ROADWAY AND STORM SEWER CONSTRUCTION PLANS  
FALCON MEADOWS AT BENT GRASS FILING NO. 3  
FALCON, CO 80831 - EL PASO COUNTY  
CHALLENGER COMMUNITIES, LLC

FUDSP-20-005 (FALCON MEADOWS AT BENT GRASS PRELIMINARY PLAN)  
SF-22-16 (FALCON MEADOWS AT BENT GRASS FILING NO. 3)

# SOPHIA LANE STREET IMPROVEMENT PLAN

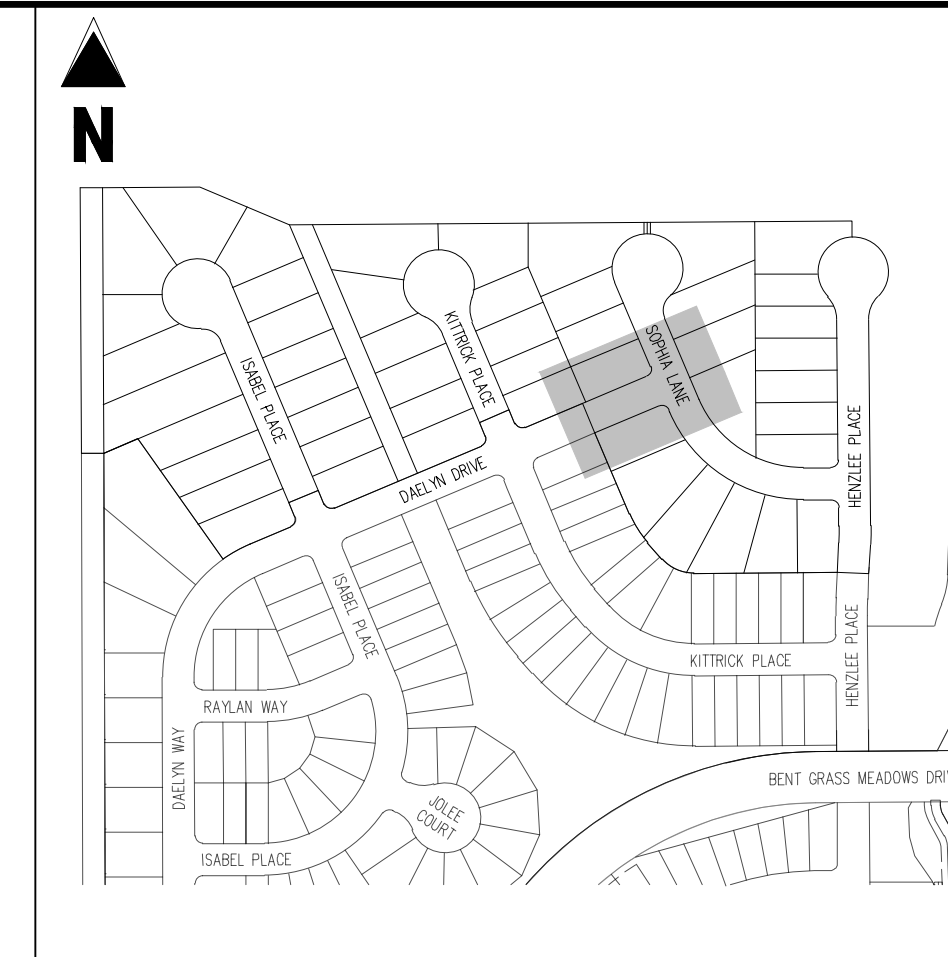
**Subject:** Callout  
**Page Label:** [8] 8 SOPHIA LANE STREET IMPROVEMENT PLAN  
**Author:** Daniel Torres  
**Date:** 7/21/2022 11:54:13 AM  
**Status:**  
**Color:** ■  
**Layer:**  
**Space:**

It appears that the indicated slope shown on the profile does not match the revised plan above. Please revise accordingly such that the 3% max slope is complied with.

**Subject:** Callout  
**Page Label:** [13] 13 INTERSECTION DETAIL  
**Author:** Daniel Torres  
**Date:** 7/21/2022 3:28:39 PM  
**Status:**  
**Color:** ■  
**Layer:**  
**Space:**

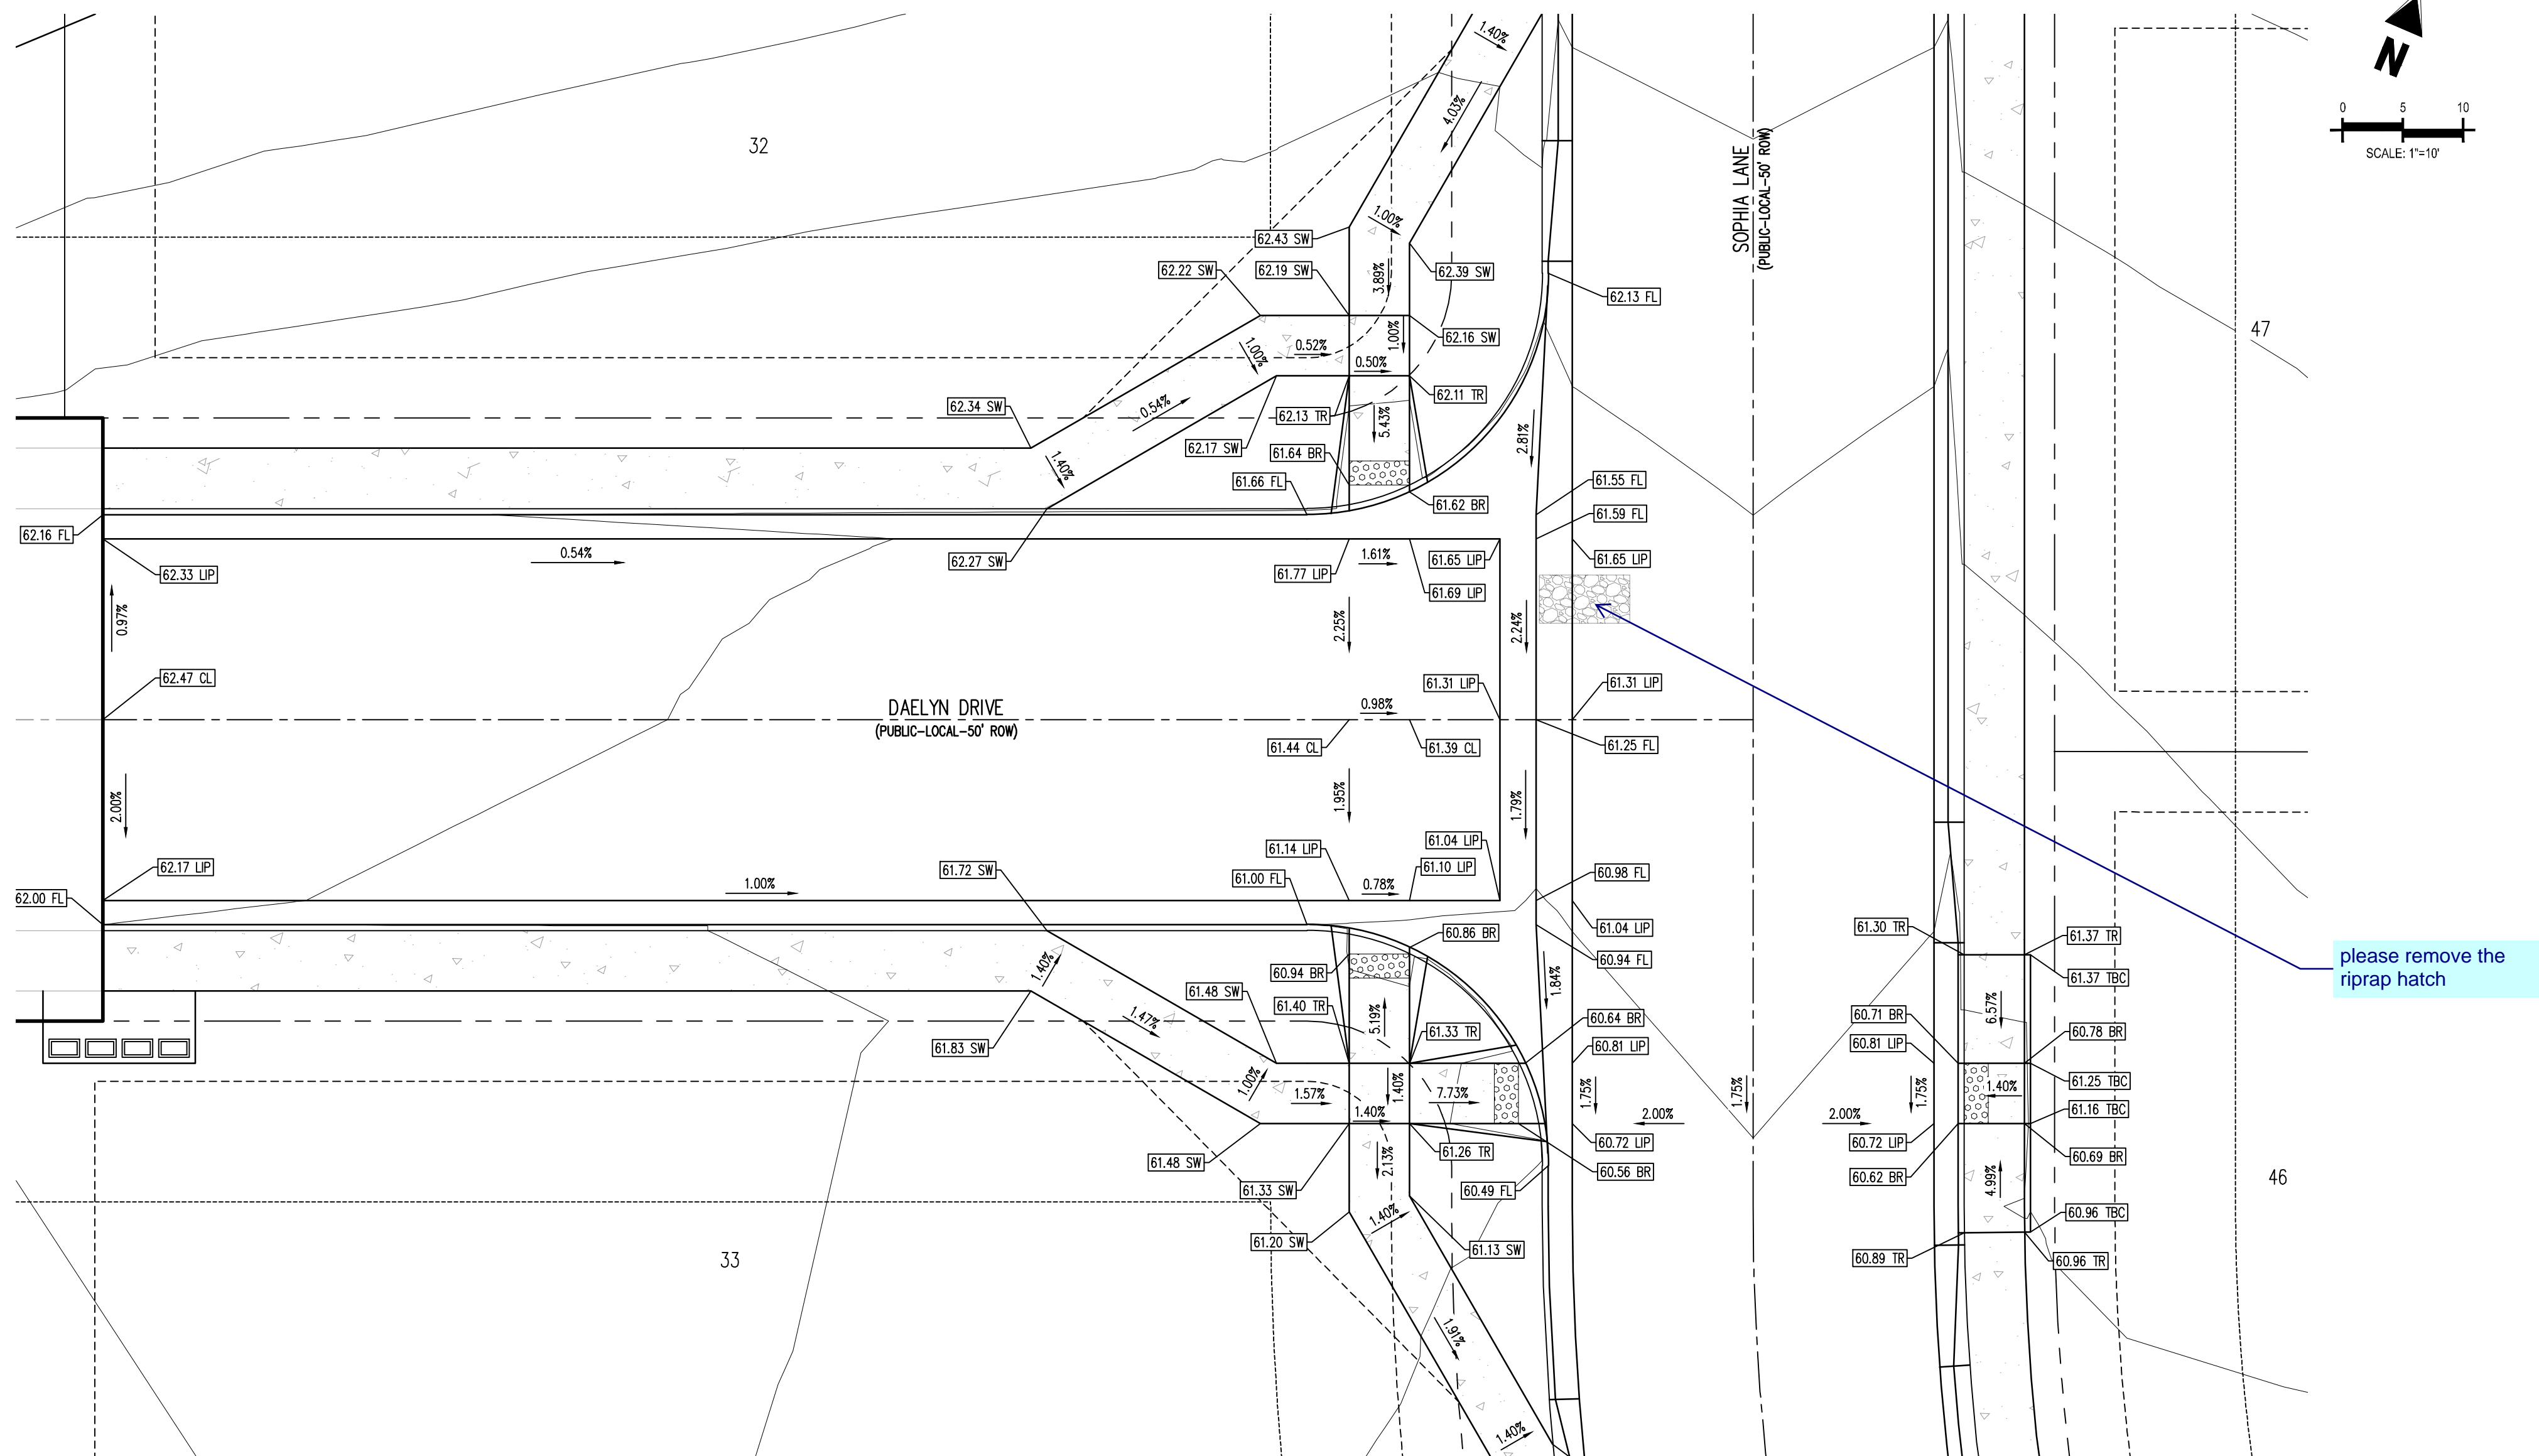
please remove the riprap hatch
